Public Comments Received by NIST on DRAFT Reports:

NIST NCSTAR 1 through NCSTAR 1-8: Federal Building and Fire Safety Investigation of the World Trade Center Disaster: Final Reports of the National Construction Safety Team on the Collapses of the World Trade Center Towers

DRAFTS FOR PUBLIC COMMENTS

June 2005

Figure 1. UL and Isolotek results.

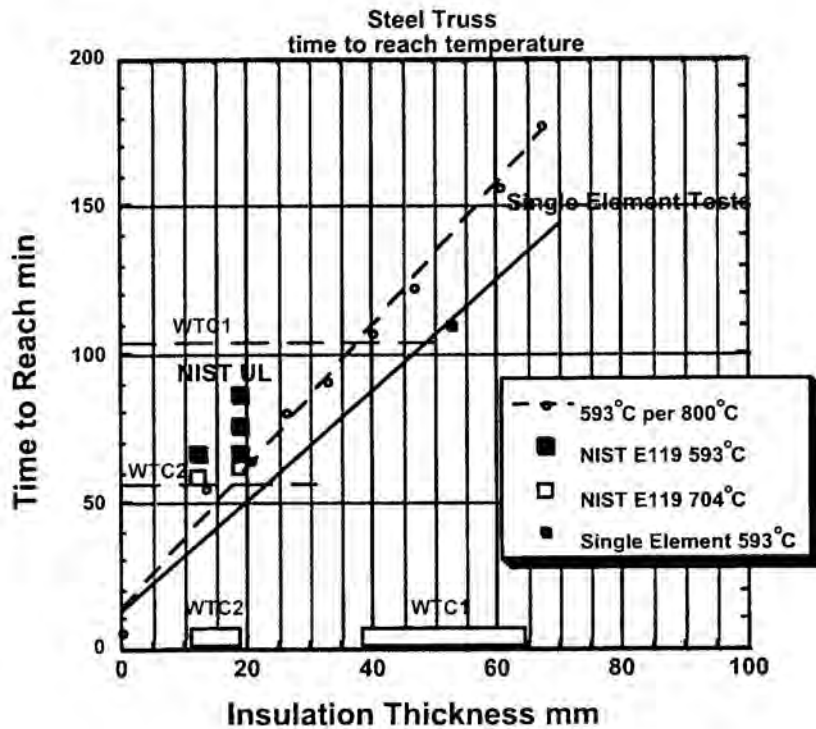
Consequently, if the truss elements with specified insulation levels of ½-¾ in. for WTC 2 and 1 ½ in. for WTC 1 can be heated to about 600 °C in an 800 °C fire at computed times of 55-73 minutes and 111 minutes, respectively, and NIST and others determined that the truss would cause either column buckling or connection failure at 600 °C or below, then this mode of collapse cannot be discounted. This is especially compelling since the collapse times are consistent at 56 and 102 minutes. Moreover, it is commonly known that floor sections were collapsing up to 20 minutes before the full collapse of each of the buildings. NIST has not addressed those early failures.

Figure 2. Predicted upper layer temperatures at various locations on the 97th Floor.

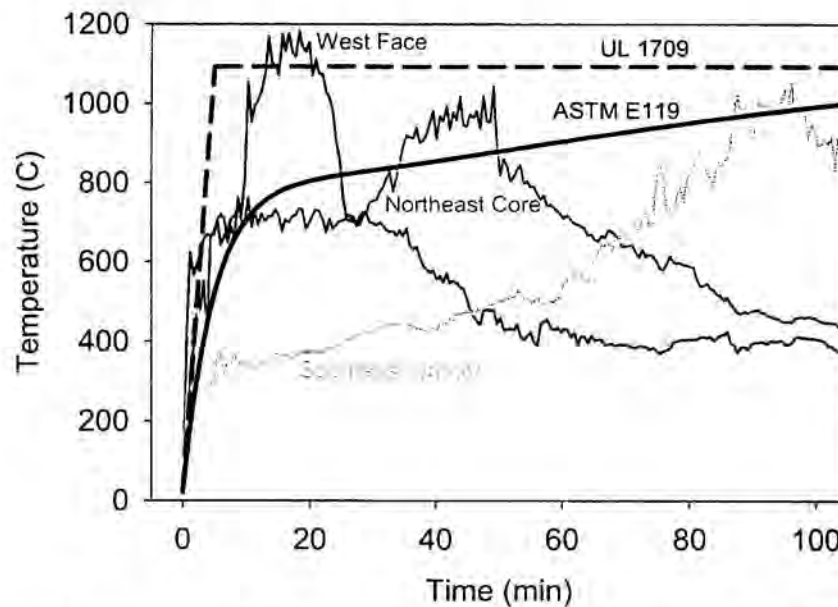
The results of the NIST fire predictions are based on a fuel loading of 4-5 psf. These levels are based on data from the impacted floors of Marsh & McLennan in WTC 1. NIST says this has “high” accuracy [p 119]. They find for WTC 1 that a given floor did not have uniform temperatures. “At any given location, the duration of temperatures near 1,000 °C was about 15 min to 20 min.” [p 127] Upper layer temperatures are shown in Figure 2 for WTC 1 97th floor [NIST]. Temperatures generally exceeded 600°C for about 30 minutes, and for about 60 minutes in the core. In contrast, a scale model test conducted at the University of Maryland, representative of the 96th floor with a simulated fuel load of 11.5 psf, shown in Figure 3 indicates temperatures are generally over 600°C (typo?, 600C) for 100 minutes, by (typo?) are much cooler in the core. These results are distinctly different from the NIST simulation. One may be dubious of scale modeling, but it is a tried and true technique.

Figure 3. Temperatures in a scale model of WTC 1 96th floor

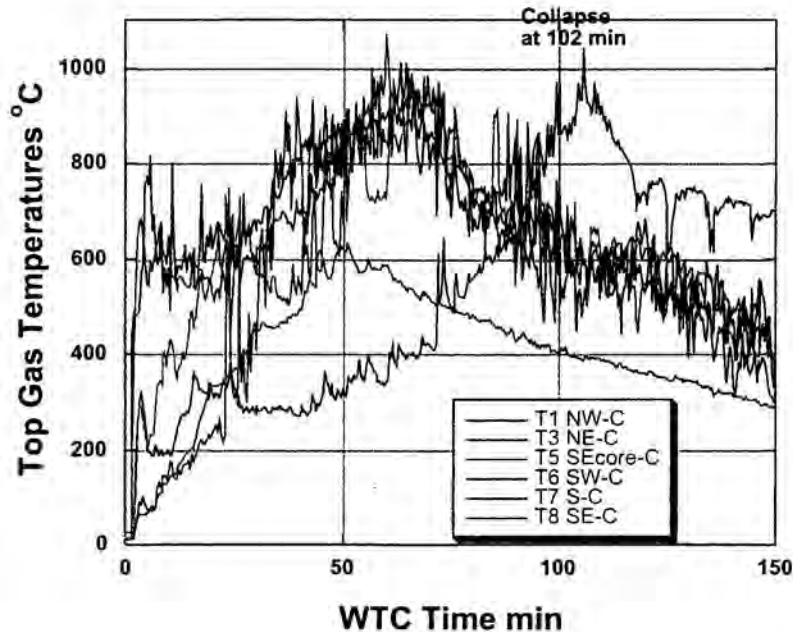
The heavier fuel load in the scale model was based on traditional office loadings and on anecdotal interviews of people familiar with the floors. Subsequently, we conducted a fuel load survey of the 96th floor based on architectural plans obtained from the furniture installer. This led to a conclusion that a loading of 10 psf or greater was the case. Appendix C contains the details in a report. Figure 4 shows a section of the architectural plans used for the 96th floor. A handwritten notation indicates a section of common files that ringed the core of the office space. There were 170 of these 4-drawer lateral files. NIST completely ignored this fuel load (and others) in their assessment. We assigned 100 lbs of paper per draw (a sub-capacity level) giving 68,000 lbs for this contribution. In addition, there were other common files and a storage room that gave a grand total of 95,400 lbs not included by NIST. In the survey conducted by Kate Stewart, estimates of paper and personal items were included in the workstation loads based on typical office conditions. Our total floor combustible loading was estimated at 302,062 lbs compared to 134,640 lbs determined by NIST. Taken over the office floor space area (31,013 ft²), this computes to 9.7 psf and 4.3 psf for NIST. Our paper estimate per file draw is well below

Figure 4. Section of furniture layout WTC 196th floor

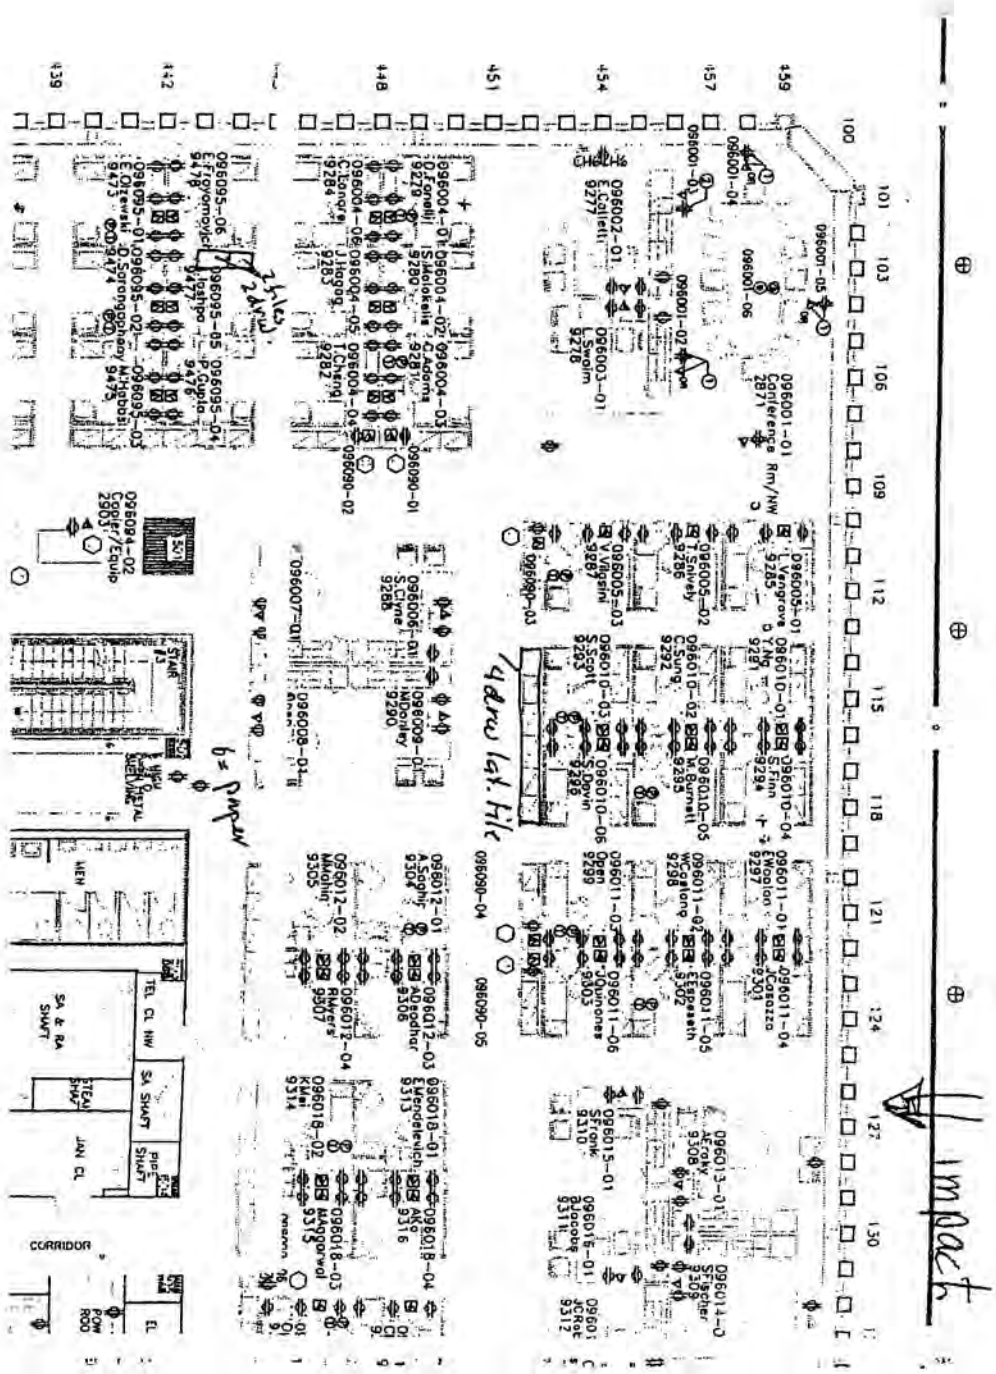
capacity, so the loading we determine is likely too low. Indeed, it was told to us that Marsh was a “paper hog” and “kept everything”. Paper fuel in closed files is de-rated in fire design considerations, but the aircraft impact could have opened the file draws.

Figure 1. UMCP estimate of how the total workstation weight is distributed.

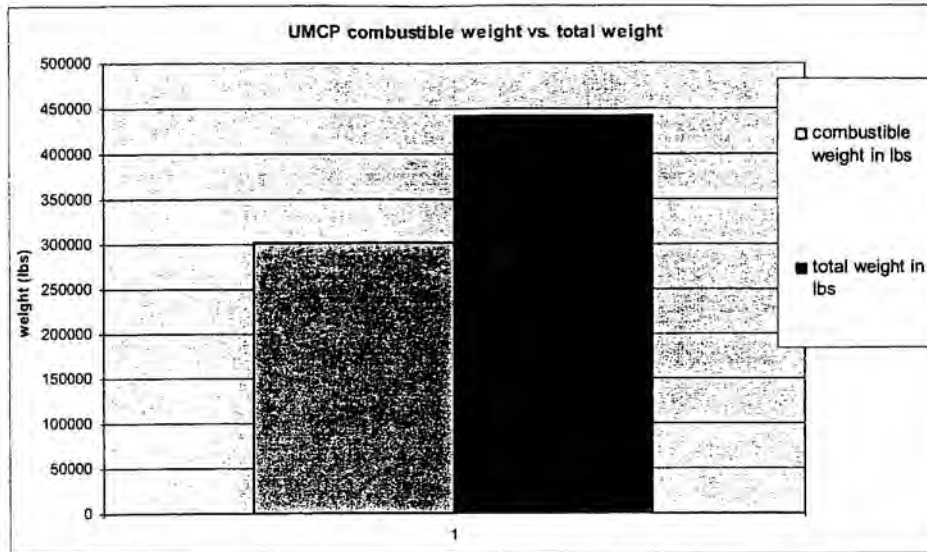
- The cabinets used by NIST contained two reams of packed paper, which is not consistent with the files that I weighed. The significance is that the tighter the packed paper is, the less air can get in to feed the fire whereas, typical files are not uniform in size or spacing and leave room for air to supply the fire.
- The following are graphical representations of the difference between the paper weight not included (NIST) and the total weight inclusion (UMCP):

**APPENDIX 1. PLAN OF WTC FLOORS 84-86 (DESIGN DWG. A-B-148)
SHOWING REMOTENESS ANALYSIS BY JAKE PAULS**

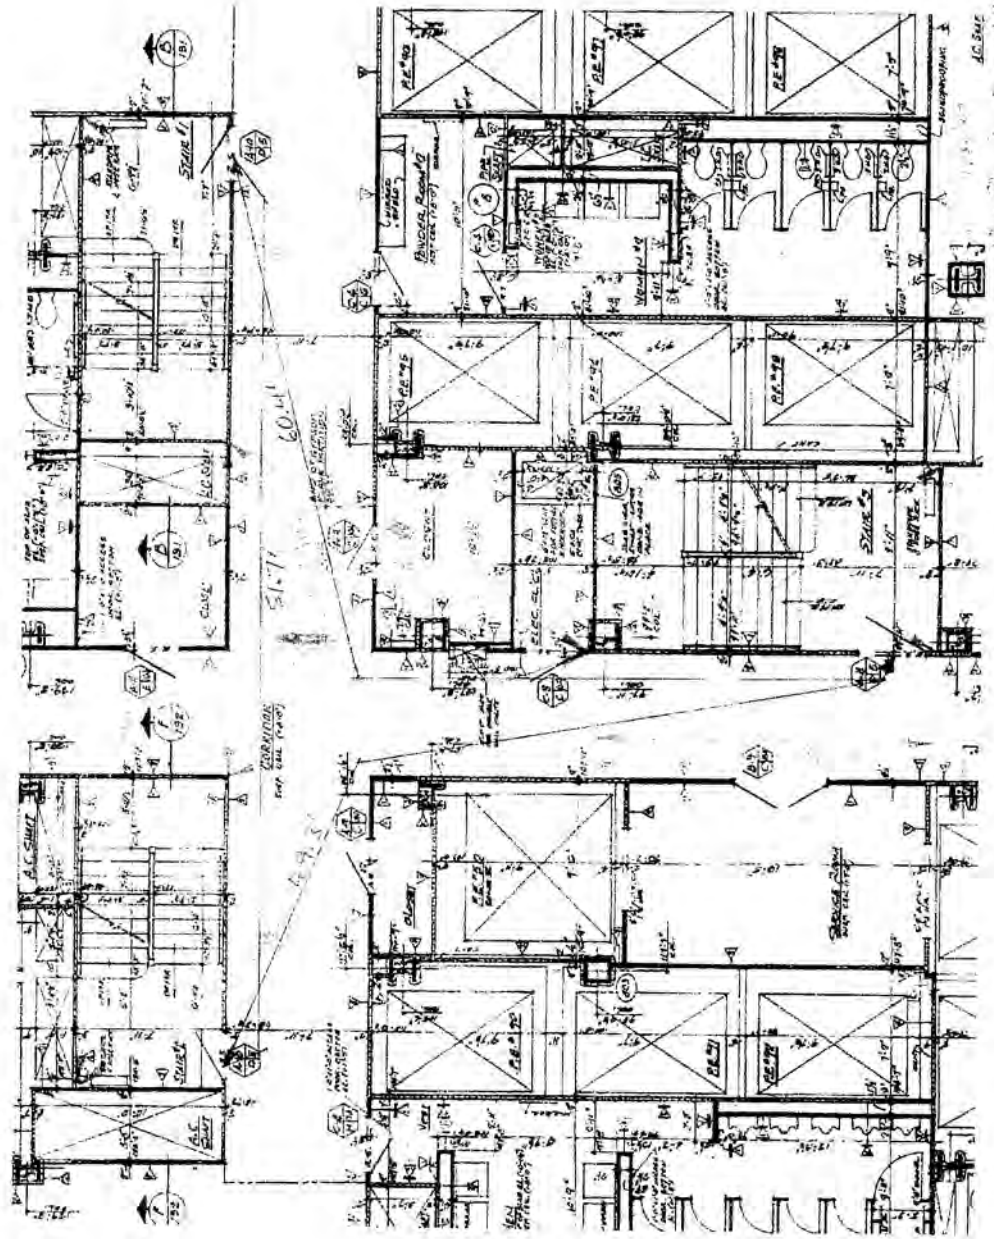
Surely it cannot be reasonably argued that the exits, especially on upper floors such as floor 96, were as far apart as was practicable nor that reasonable redundancy was provided. Moreover, contributing to my professional opinion that NIST is unreasonably de-emphasizing the role of exit remoteness, is its flawed assessment of the degree with which the WTC towers complied with the NYC building code at the time of its design. Specifically, as discussed above in relation to my Figure 1, the three exits in the impact zone of WTC1 complied with neither the spirit nor the letter of the NYC building code of 1968. Yet NIST NCSTAR 1, on page 58, asserts the following.

Photos

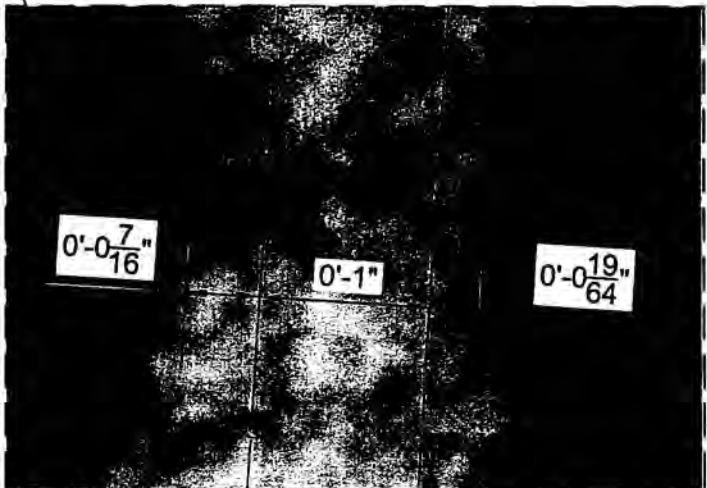
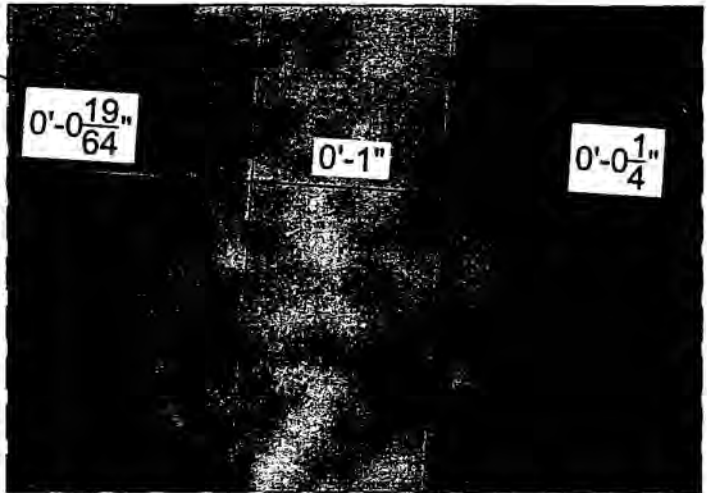
Close review of the site inspection photos reveal areas of missing or thin dryspray fireproofing coverage on the structural steel joists (see Photos 1 through 10). These photos were chosen because they show enough exposed webbing to allow for an accurate measurement of the one-inch diameter web members. Using the one-inch dimension as a reference, it was possible to determine the thickness of the fireproofing adjacent to the bare metal area on the web members as well as on web members shown in the same plane within the photo. Fireproofing thicknesses ranged from 0" (Photo 7) to 0.55" (35/64" Photo 3), with an average thickness of 0.30" (see Table – 2). Photo 6 includes a web located in the foreground that was not included in the evaluation. This particular web is atypical in that it is almost entirely exposed and if included in the evaluation it would have skewed the resulting average.

Fig. 3. Pivoting of upper part of tower about its base, (a,b) with and without horizontal shear at base; (c) Model for simplified analysis; (d) Free-body diagram with inertia forces; (d,e) Plastic horizontal shearing of columns in critical floor at base

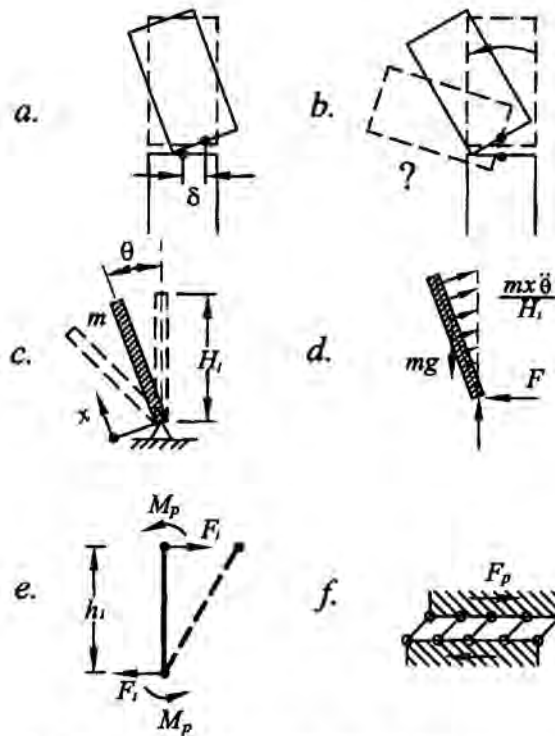
The World Trade Center was designed for an impact of a Boeing 707-320 rather than a Boeing 767-200. But note that the maximum takeoff weight of that older aircraft is only 15% less than that of a Boeing 767-200. Besides, the maximum fuel tank capacity of that aircraft is only 4% less. These differences are well within the safety margins of design. So the observed response of the towers proves the correctness of the dynamic design. What was not considered in design was the temperature that can develop in the ensuing fire. Here the experience from 1945 might have been deceptive. That year, a two-engine bomber (B-25), flying at about 400 km/h, hit in fog the Empire State Building (381-m tall, built in 1930) at the 79th floor (278 m above ground)—the steel structure suffered no significant damage, and the fire was confined essentially to one floor (Levy and Salvadori 1992).

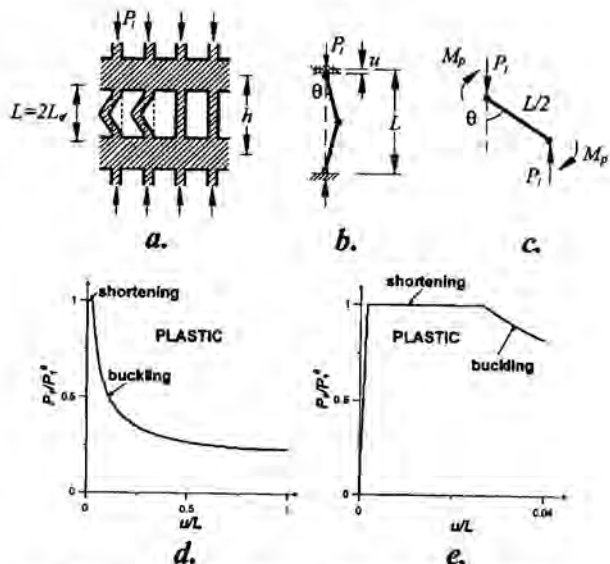
Since F is proportional to $\sin 2\theta$, its value becomes equal to the plastic limit when $\sin 2\theta = 1/10.3$. From this we further conclude that the reaction at the base of the upper part of South Tower must have begun shearing the columns plastically already at the inclination

which defines the curve plotted in Fig. 5. This curve is an optimistic upper bound since, in reality, the plastic hinges develop fracture (Bažant and Planas 1998), and probably do so already at rather small rotations.

Figure 1. UL and Isolotek results.

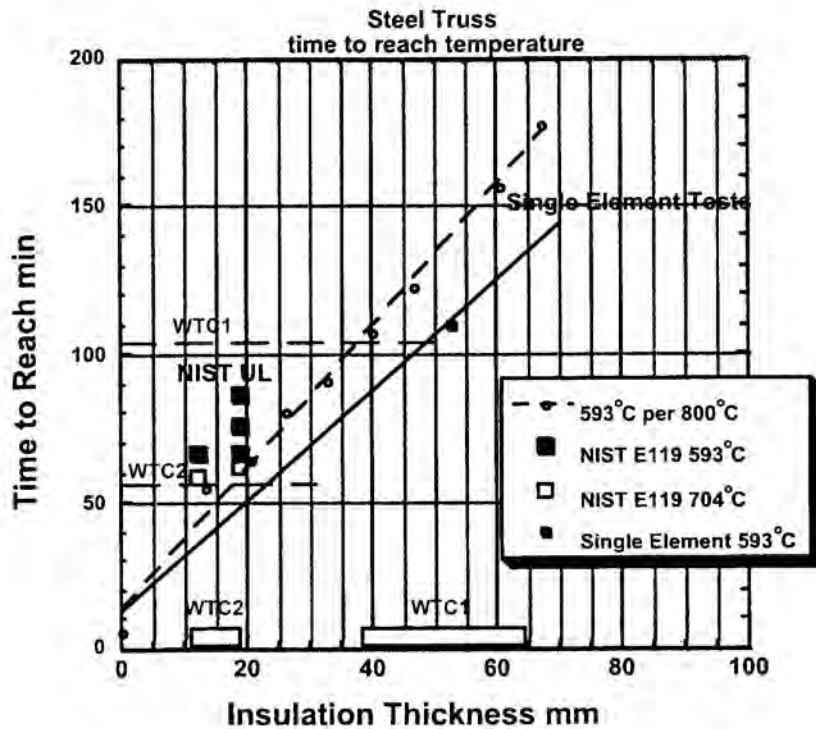
The results of the NIST fire predictions are based on a fuel loading of 4-5 psf. These levels are based on data from the impacted floors of Marsh & McLennan in WTC 1. NIST says this has “high” accuracy [p 119]. They find for WTC 1 that a given floor did not have uniform temperatures. “At any given location, the duration of temperatures near 1,000 °C was about 15 min to 20 min.” [p 127] Upper layer temperatures are shown in Figure 2 for WTC 1 97th floor [NIST]. Temperatures generally exceeded 600°C for about 30 minutes, and for about 60 minutes in the core. In contrast, a scale model test conducted at the University of Maryland, representative of the 96th floor with a simulated fuel load of 11.5 psf, shown in Figure 3 indicates temperatures are generally over 600°C (typo?, 600C) for 100 minutes, by (typo?) are much cooler in the core. These results are distinctly different from the NIST simulation. One may be dubious of scale modeling, but it is a tried and true technique.

Figure 1. UL and Isolatek results.

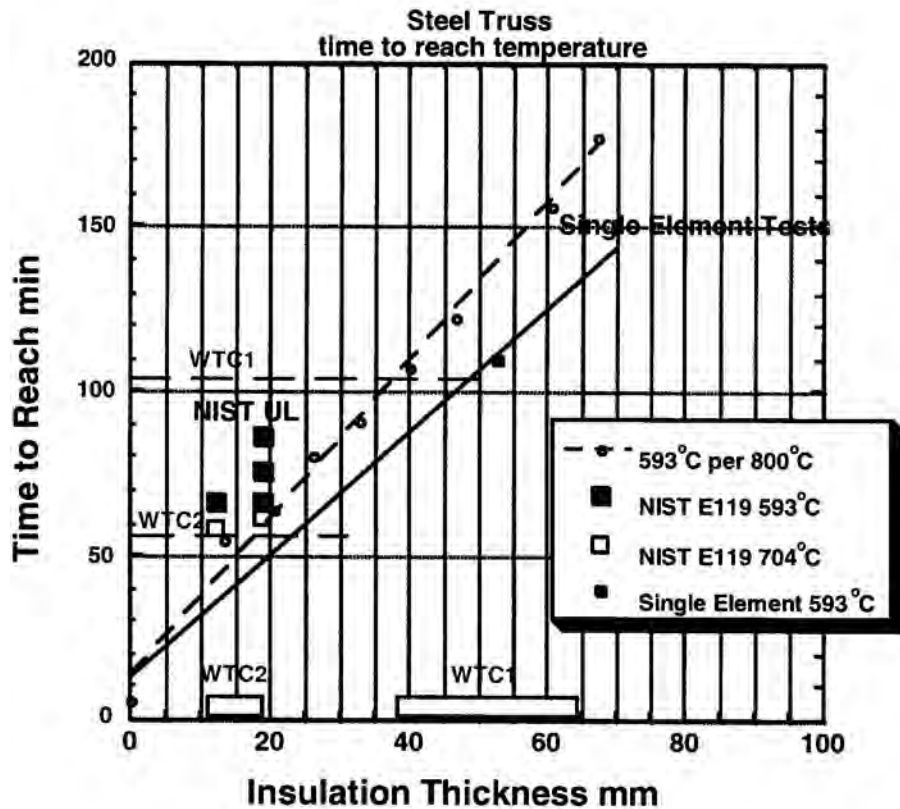
The results of the NIST fire predictions are based on a fuel loading of 4-5 psf. These levels are based on data from the impacted floors of Marsh & McLennan in WTC 1. NIST says this has “high” accuracy [p 119]. They find for WTC 1 that a given floor did not have uniform temperatures. “At any given location, the duration of temperatures near 1,000 °C was about 15 min to 20 min.” [p 127] Upper layer temperatures are shown in Figure 2 for WTC 1 97th floor [NIST]. Temperatures generally exceeded 600°C for about 30 minutes, and for about 60 minutes in the core. In contrast, a scale model test conducted at the University of Maryland, representative of the 96th floor with a simulated fuel load of 11.5 psf, shown in Figure 3 indicates temperatures are generally over 600°C for 100 minutes, but are much cooler in the core. These results are distinctly different from the NIST simulation. One may be dubious of scale modeling, but it is a tried and true technique.

Figure 1. UL and Isolotek results.

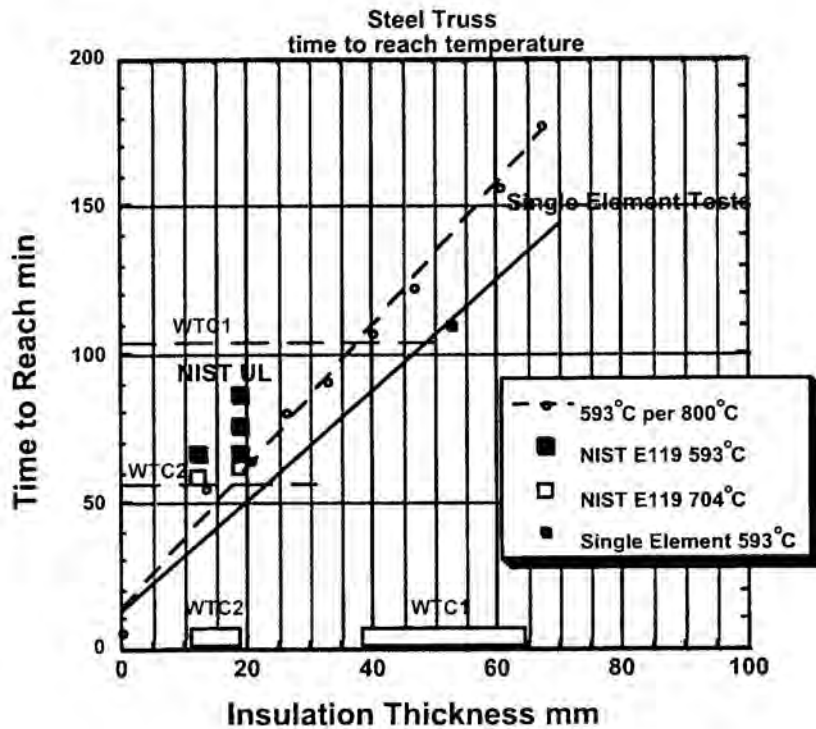
The results of the NIST fire predictions are based on a fuel loading of 4-5 psf. These levels are based on data from the impacted floors of Marsh & McLennan in WTC 1. NIST says this has “high” accuracy [p 119]. They find for WTC 1 that a given floor did not have uniform temperatures. “At any given location, the duration of temperatures near 1,000 °C was about 15 min to 20 min.” [p 127] Upper layer temperatures are shown in Figure 2 for WTC 1 97th floor [NIST]. Temperatures generally exceeded 600°C for about 30 minutes, and for about 60 minutes in the core. In contrast, a scale model test conducted at the University of Maryland, representative of the 96th floor with a simulated fuel load of 11.5 psf, shown in Figure 3 indicates temperatures are generally over 600°C (typo?, 600C) for 100 minutes, by (typo?) are much cooler in the core. These results are distinctly different from the NIST simulation. One may be dubious of scale modeling, but it is a tried and true technique.
